# AIMOC WIM

02 - Modular static + WIM, side by side

CONFIDENTIAL - CONCEPT

## PLAN · Static 18 × 3 m + WIM

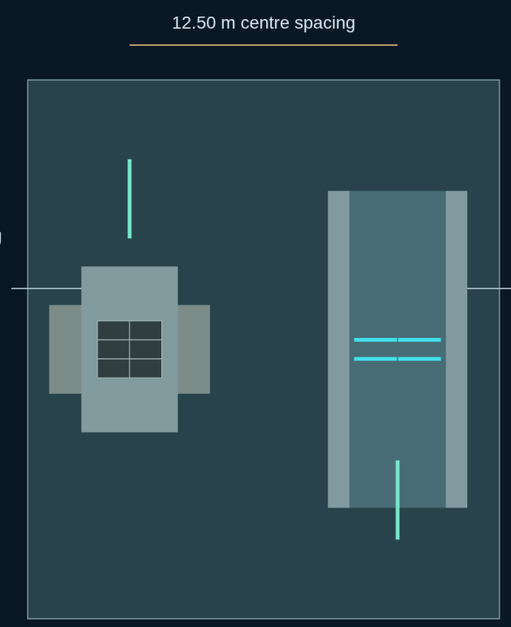
22 × 170 m concept corridor; loop excluded

*Ramps, landings, raft and elevations: coordination assumptions; OEM foundation unavailable.

## SECTION · STEEL MODULES AND SUPPORTS

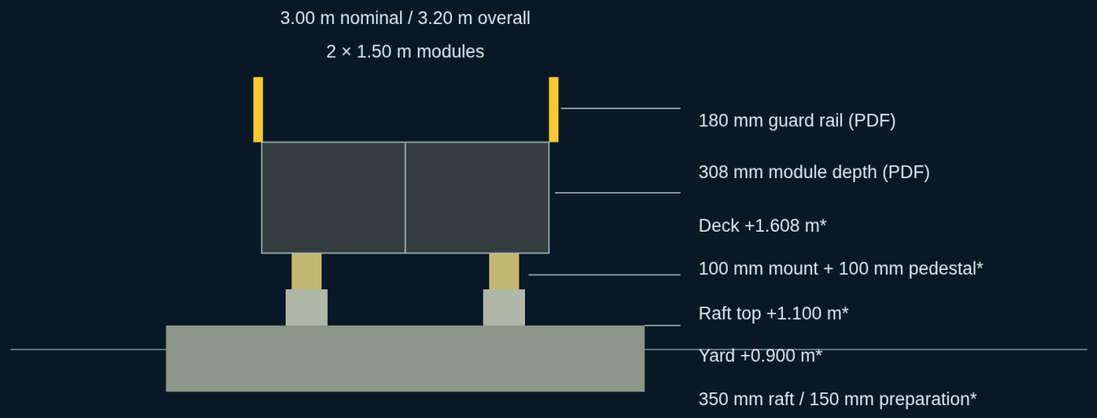
*Civil assumptions for reclaimed ground, not Static foundation details. Vertical scale exaggerated.

308 mm is total module depth, not steel plate thickness. 3D mount sizes/positions are illustrative.

Civil assumptions: 28 x 7.5 x 0.35 m raft; 100 mm pedestal; 100 mm mount; 308 mm module. OEM reinforcement, concrete grade, anchors and bearing design are not supplied. Verify settlement, flooding, drainage, corrosion and WIM interaction before construction.
